# Product Bulletin

## FoamDDI 1.17 Software Release

July, 2025

### Dark Sample Detection

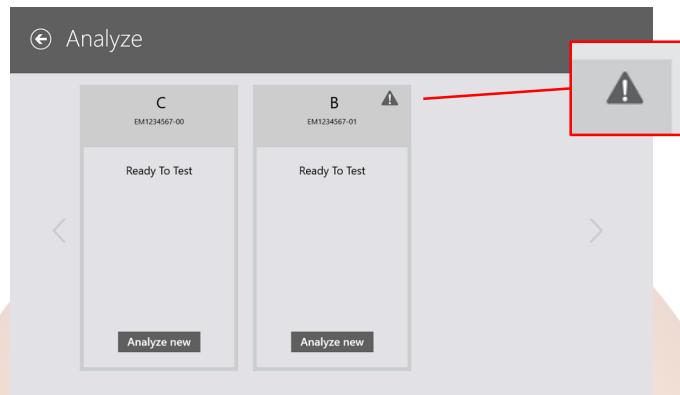
The system now facilitates the analysis of darker-colored samples, such as dark brown, blue, purple, red, dark red, and near-black, through the integration of an IR lamp and a revised LED/lamp sequence. The IR lamp is activated during each primary capture (Sample, Tendency, and final Stability), thereby ensuring consistent illumination and enhancing foam-detection accuracy. This also preserves visibility in the event of a lower LED malfunction. These advancements similarly benefit the imaging of clear and neutral-toned samples.

## Module Missing Status

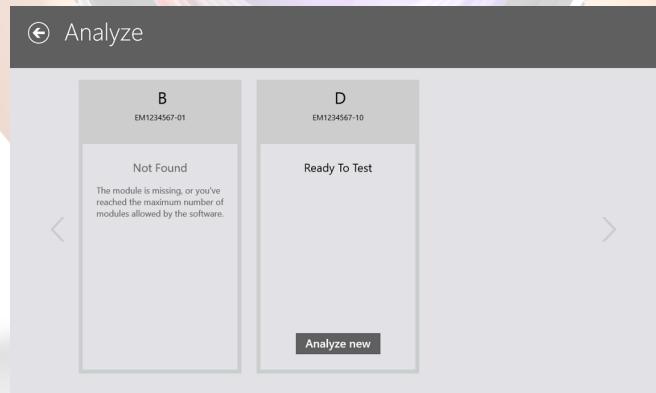
The module now distinguishes between devices that have never been found (or connected) and those that have unexpectedly lost connection. Only devices that have lost connection will continuously attempt to reconnect. This improved status indication allows users to immediately identify which modules are present and which are offline.

## More Calibration Points

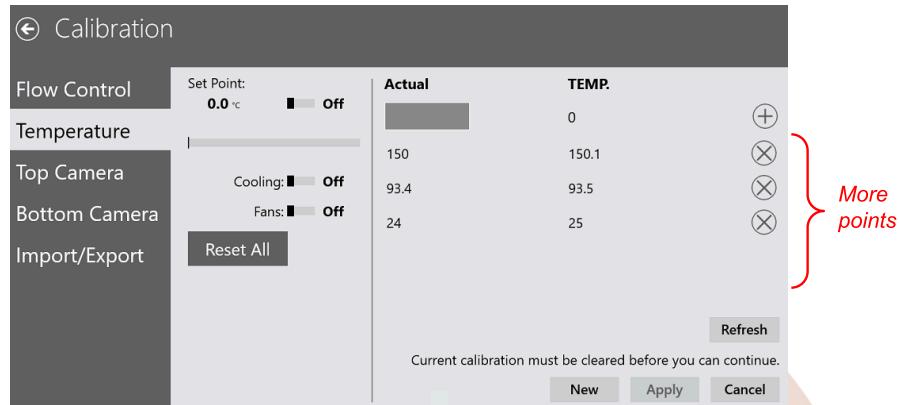
Calibration Points have been expanded to allow up to four calibration points for Temperature and Flow (up from two).

## Default Calibration Active Warning

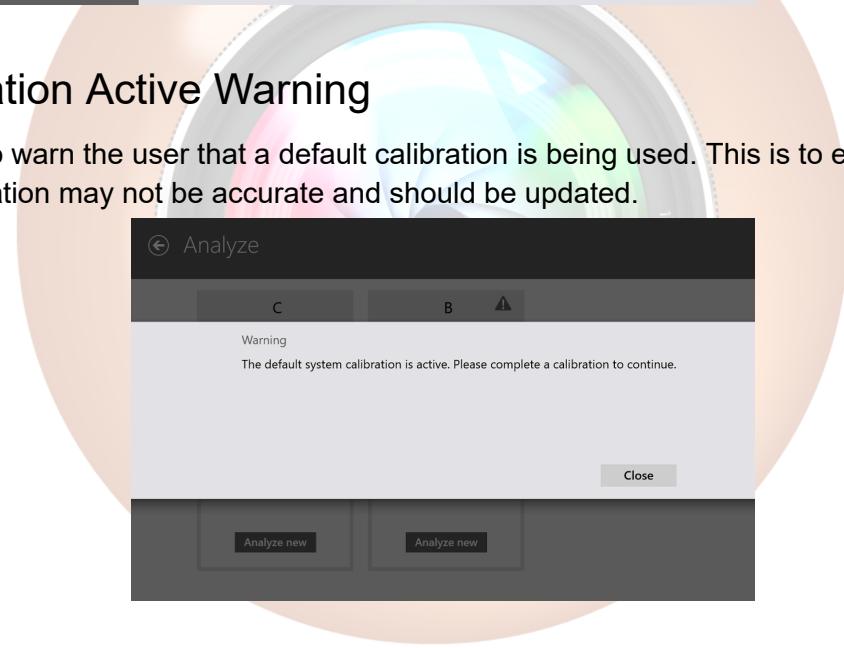
A message is used to warn the user that a default calibration is being used. This is to ensure that the user is aware that the calibration may not be accurate and should be updated.
